Medium Trucks  
> FLC 112 Conventional

**Freightliner  
Service Bulletin**

**Fig. 1, Radiator Brace Installation**

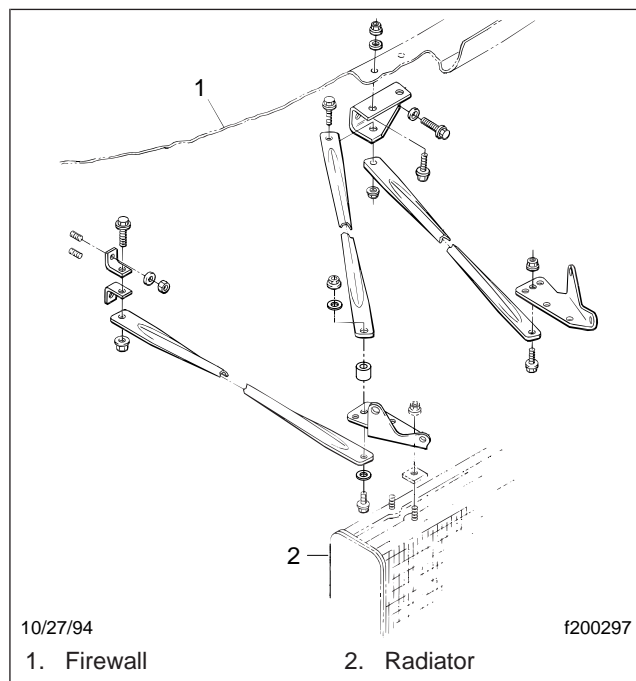
Because the Cummins NTC engine is long, when equipped with a Kysor on-off fan clutch, the fan may contact and damage the radiator even when no fan spacer is installed.

In production, longer radiator braces were developed to tilt the radiator further from the fan in these applications. If an installation as described above experiences fan/radiator contact, replace the original radiator braces (see Fig. 1) with the longer versions. See Table 1 for part numbers and descriptions. Use the original fasteners when installing the new braces.
